DEVIATION REQUEST FORM

Deviation Defended Number	DEV 276	
Deviation Reference Number	DEV_276	
Date of decision	04/07/2022	
Precedent (YES/NO)	No	
Precedent details	N/A	
Date of submission	17/06/2022	
Project/PoA/VPA	Project	ID – GSXXXX
	⊠ PoA	ID - GS1988
	⊠ VPA	ID - GS2758
Project/PoA/VPA title	PoA GS1988: Proyecto Mirador Enhanced Distribution of Improved Cookstoves in Latin America VPA GS2758: Proyecto Mirador Enhanced Distribution of Improved Cookstoves in Latin America - First VPA for Distribution of Dos por Tres Cookstoves in Honduras	
Date of listing	29 June 2010 (Registration date of stand-alone project activity with Project ID GS690) 3 June 2014 (Registration date for PoA GS 1988) Note: At the time of PoA registration, the stand-alone project activity (GS690) became GS2758, the First VPA under PoA GS1988.	
GS Standard version applicable	PoA GS1988: v2.2, transition to GS4GG completed on 30/01/2019 VPA GS2758: Gold Standard for the Global Goals

Title/subject of deviation	VPA GS2758 residual credits to be collected in new VPA	
Specify applicable rule/requirements/methodology, with exact paragraph reference	Programme of Activity Requirements and Procedures, version 2.0 Parag

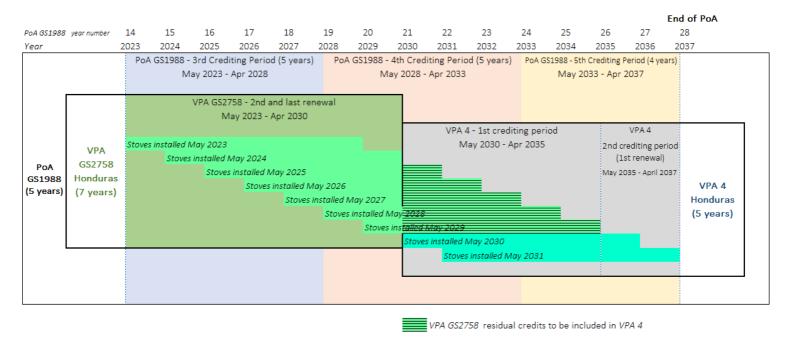
The following chart shows how only stoves installed between 01 May 2023 and 30 April 2024 will be able to claim the full 6 years of emission reductions under *VPA GS2758*, whereas stoves built after 1 May 2024 will progressively generate less than 6 years of credits under *VPA GS2758*.

If *VPA GS2758* ceases to generate VERs as of 30 April 2030, and *VPA 4* cannot generate residual VERs for cookstoves installed under *VPA GS2758*, then the implications to Proyecto Mirador would include the following:

- All cookstoves built after 1 May 2024 must be accounted for under VPA 4 in order to ensure those cookstoves continue to generate residual credits through their 6th year.

- We must add VPA 4 with a start date of 1 May 2024 and continue running VPA
 GS2758 concurrently with VPA 4 for 6 years going forward.
- From 1 May 2024 forward, VPA GS2758 would be limited to include only residual VERs generated from cookstoves built before 1 May 2024, despite the fact VPA GS2758 does not expire until 2030.

The request is not approved as no provisions under the GS4GG allow the projects to claim residual credits of one VPA into another.
